Technical Service Information

CHRYSLER A904 SURGING BETWEEN 35-55 MPH

This bulletin supersedes Technical Service Bulletin 18-55-86, which should be removed from your files.

Figure 1

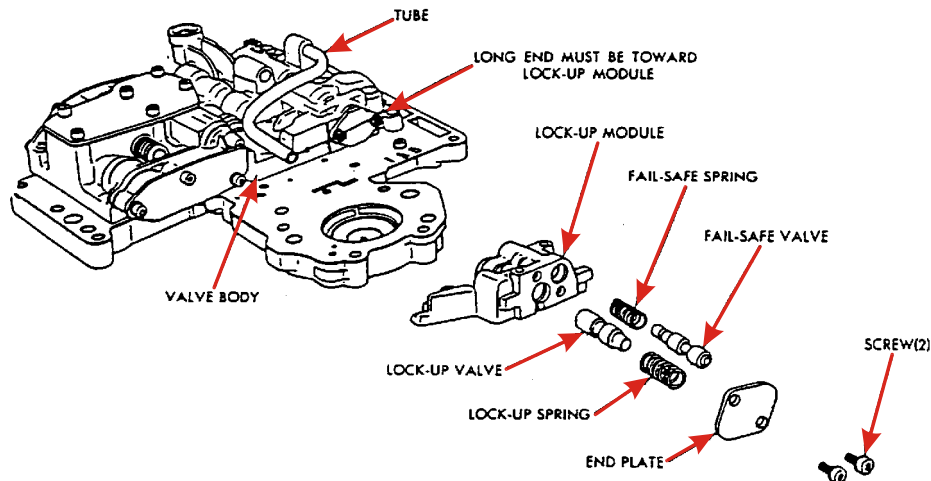
This repair involves replacement of the transmission lock-up spring and a revised ESA/EFC module. The lock-up speed will be raised from approximately 43 mph to 53 mph.

1. Raise vehicle on hoist, remove shift linkage and kickdown linkage, drain transmission fluid, and remove transmission pan.
2. Lower valve body just enough to remove torque converter lock-up spring, replace with supplied spring, PN 4202672. Re-use the existing lock-up valve, fail safe valve and spring, cover, and screws (Figure 1).
3. Reinstall valve body and torque screws to 100 inch pounds.
4. Reinstall transmission oil pan using supplied gasket, PN 4295875. Reconnect shift and kickdown linkage. Lower vehicle and refill using transmission fluid, PN 4318077. Adjust shift and kickdown linkages per the service manual procedures.
5. Remove ESA and replace with supplied ESA, PN 4379255.
6. Type Authorized Modification Label, PN 4275086, as shown in Figure 2 and attach near VECI label.
